UNITED STATES PATENT AND TRADEMARK OFFICE

APPLICATION NO.	FILING DATE	FIRST NAMED INVENTOR	ATTORNEY DOCKET NO.	CONFIRMATION NO.
09/917,749	07/31/2001	Yasutaka Ito	110575.01	2777

Office Action Summary

DETAILED ACTION***Drawings***

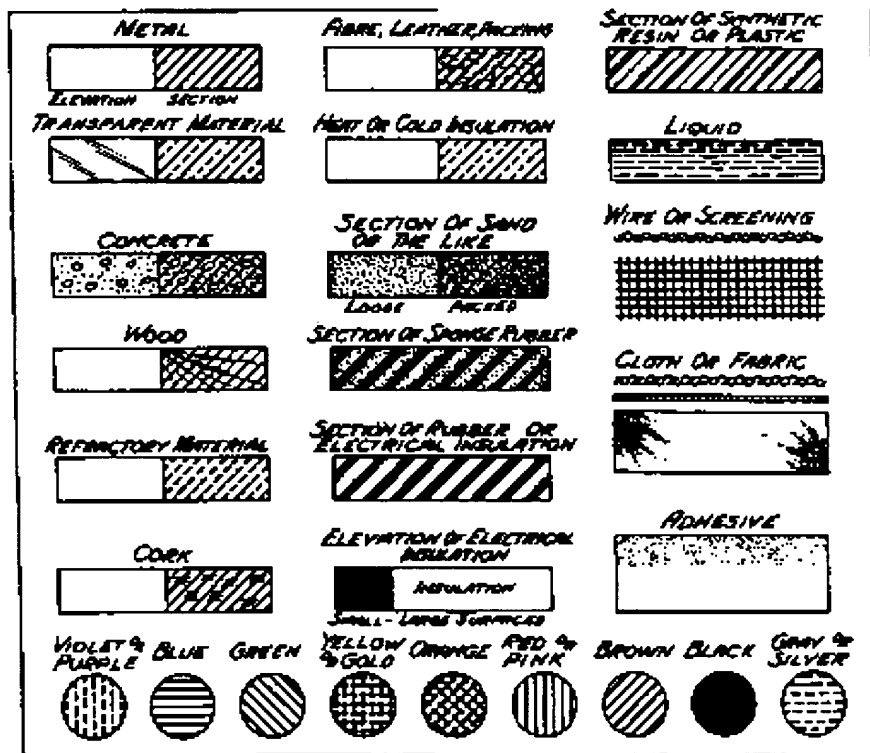
The drawings are objected to because of the following informalities:

Figs. 1-3, 5, 7-11, 13: Proper cross-sectional hatching is required to properly denote refractory materials in accordance with MPEP 608.02 (see the drawing below for proper hatching examples). The submitted proposed correction shows metallic hatching--not refractory hatching.

The response to this action must include a separate letter addressed to the examiner and contain: (1) sketches showing in red the drawing changes required above and (2) a request that the examiner approve the changes as shown on the sketches.

IMPORTANT NOTE: The filing of new formal drawings to correct the noted defect may be deferred until the application is allowed by the examiner, but the print or pen-and-ink sketches with proposed corrections in red ink is required in response to this office action, and may not be deferred.
